Informal Document No. **GRRF-63-32**
(63rd GRRF, 4-8 February 2008
agenda item 10(b))

Alignment of Regulations Nos. 13 and 13-H

Proposal for amendments to Regulation No. 13-H
(Braking)

Submitted by the expert from the European Commission (EC)

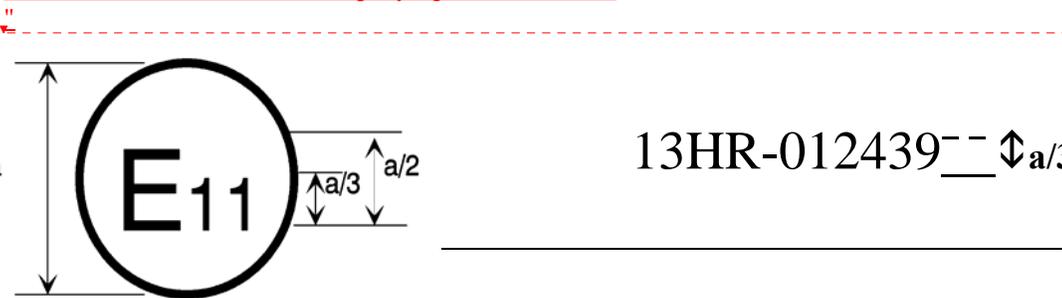
Amend model 'A' and the accompanying text as follows:

The above approval mark..... under approval number 012439. The first two digits of the approval number indicate that the approval was granted in accordance with the requirements of the 01 series of amendments to Regulation No. 13-H."

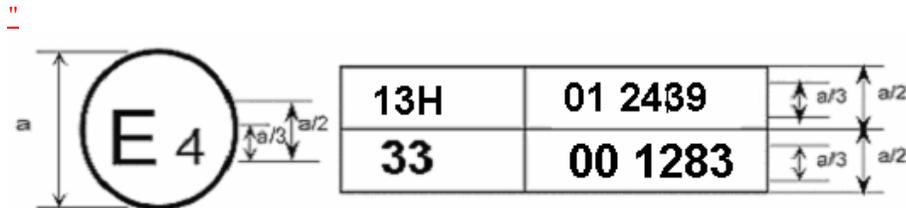
Amend model 'B' and the accompanying text as follows:

The above approval mark affixed to a vehicle shows that the vehicle type concerned has been approved in the Netherlands (E4) pursuant to Regulations Nos. 13-H and 33^{1/}. The approval numbers indicate that, at the dates when the respective approvals were given, Regulation 13-H included the 01 series of amendments and Regulation 33 was in its original form."
